SAB-EEC-88-029

REVIEW OF THE  
UNDERGROUND STORAGE TANK (UST)  
RELEASE SIMULATION MODEL

ENVIRONMENTAL ENGINEERING COMMITTEE  
SCIENCE ADVISORY BOARD  
U.S. ENVIRONMENTAL PROTECTION AGENCY

# Rough Calculation of UST Leak Volatilization

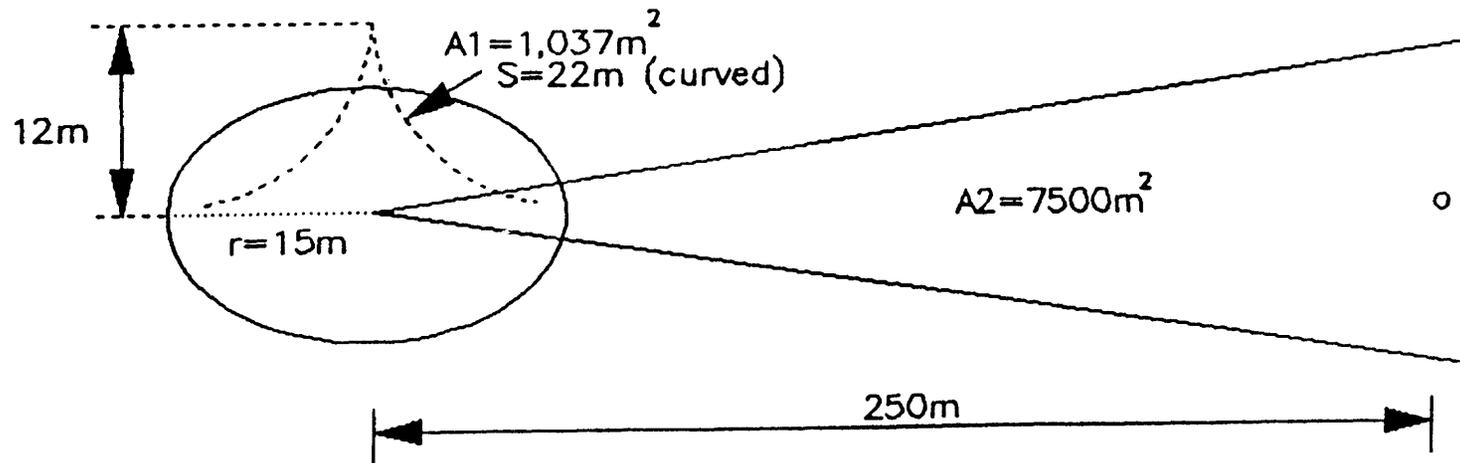
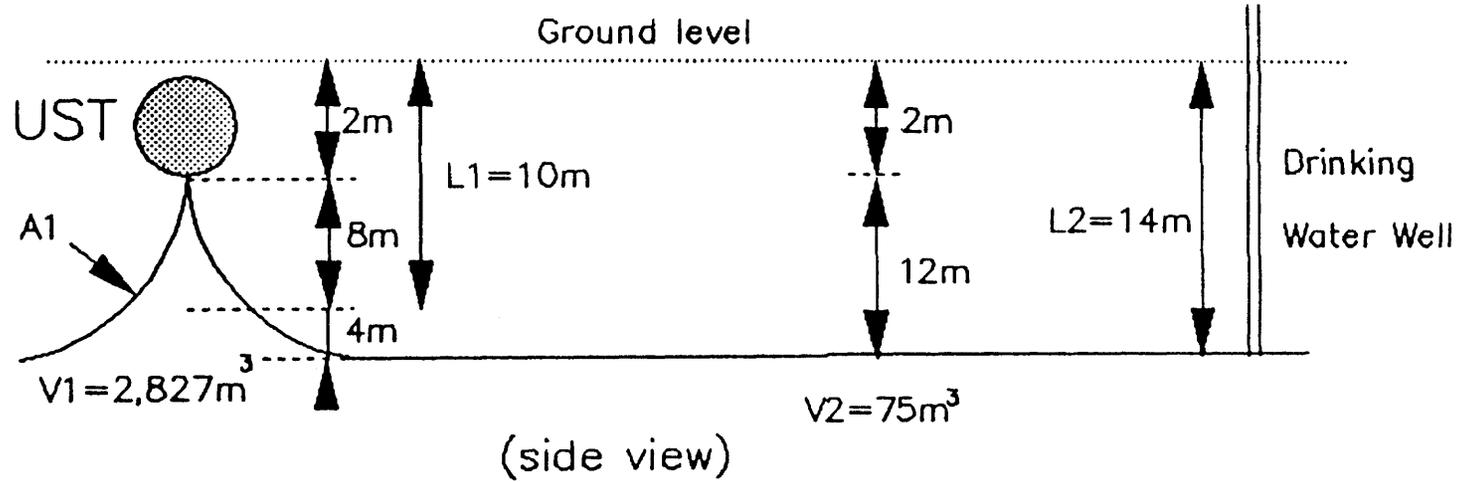
2. The air pathway is inadequately considered. Volatilization of constituents, including benzene, may well affect UST releases (see Appendix C). Spills may volatilize before they infiltrate to ground water. Constituents may also volatilize from the unsaturated and saturated zone plumes. Not only will this mechanism affect ground water releases, but it also creates a new pathway for risks. Unless a rationale exists for discounting volatilization, such releases and their movement should be considered.

Case 1 loss to air:  $90,962/1.01 \times 10^8 = 0.068\%$  of total

Case 2 loss to air:  $475,000/6.75 \times 10^6 = \underline{7.040\%}$  of total

7.108% of gasoline lost to air

Note: The gasoline vapor can migrate to basements via pipeline trenches.
